From: HUTCHINS, Steven [sph@nei.org]
Sent: Tuesday, September 08, 2009 11:16 AM
To: Frumkin, Daniel
Cc: Weerakkody, Sunil; Klein, Alex
Subject: Proposes changes to NEI 00-01 R2 Section 3.5.1 and Appendix E to address NRC Comments
Attachments: NEI 00-01 R2 Revised Circuit Failure Criteria post ACRS Mtg.pdf; Appendix E - Proposed Change to Rev 2.pdf

Dan. In an effort to resolve the remaining differences between NEI 00-01, Rev.2 and RG 1.189, R2, here are some changes NEI will be making to NEI 00-01, Rev.2. If agreed, we will issue an addendum to the NEI document, so the revision number will not change.

3.5.1 CRITERIA/ASSUMPTIONS

APPENDIX E

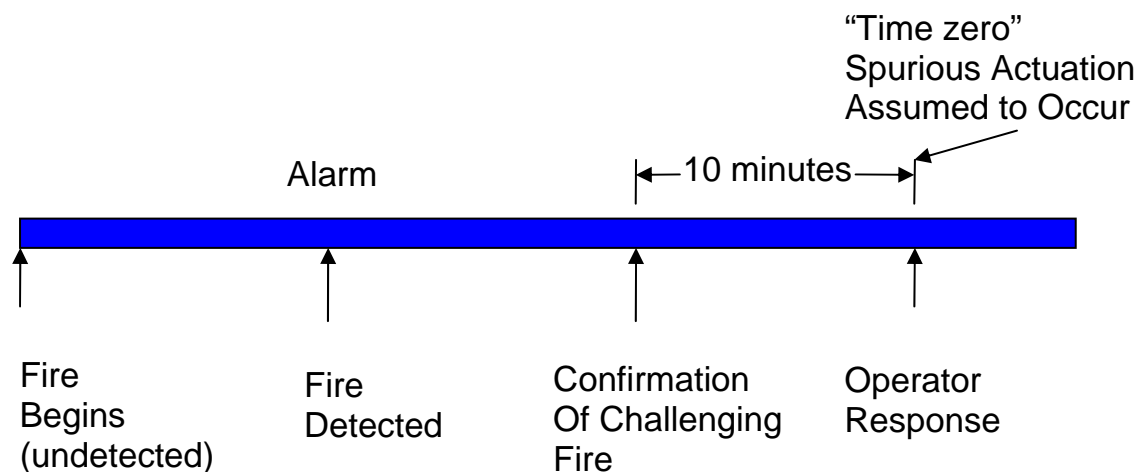
In assessing the acceptability of an operator manual action, timing is a consideration. To define the time available to perform an operator manual action, the time when fire damage to safe shutdown components and circuits occurs needs to be defined. This time is referred to as time zero. With time zero and a defined time line for the post-fire safe shutdown scenario defined, the time when specific fire-induced failures to specific systems performing specific safe shutdown functions result in adverse impacts to safe shutdown can be determined. The time line for post-fire safe shutdown is determined based on the capabilities of the systems and components being used to achieve and maintain post-fire safe shutdown in each particular fire area. This requires a plant unique analysis. Time zero, however, is an analytically assumed initial condition that must be specified and, when specified, justified as to its reasonableness.

Based on this, time zero is specified to 10 minutes after the confirmation by plant personnel that the unit is experiencing a challenging fire. Indication of the fact that the fire being experienced is challenging is based on observations by plant operations

personnel that results in the need to scram the unit, ~~and to close the MSIVs~~. Coupled with this assumption of a unit scram, assuming closure of the MSIVs (for BWRs) is a necessary assumption to provide boundary conditions on any analysis performed to determine the amount of time available prior to impacting safe shutdown. Assuming closure of the MSIVs (for BWRs) is a conservative assumption since many events will result in an MSIV closure. A fire induced loss of offsite power will result in a closure of the MSIVs (for BWRs). Additionally, the availability of multiple support systems, e.g. instrument air, is required to keep the MSIVs open (for BWRs). Finally, there are multiple automatic closure signals that will result in closure of the MSIVs (for BWRs). These closure signals could be simulated by fire-induced circuit failures.

Based on this ~~definition~~, unit scram and MSIV closure (for BWRs) may also be used as initial conditions applicable to any analysis assessing plant impacts as a result of fire-induced damage.

The figure below depicts this definition of time zero.

Linking confirmation of a challenging active fire ~~and allowing a to the beginning of the~~ 10 minute time frame for operator recognition and response before any fire-induced failures, including spurious equipment operations, occur is not only consistent with the current licensing basis, it is also consistent with the practical implementation of any safe shutdown strategy requiring operator initiation of plant safety systems. In actuality, if a
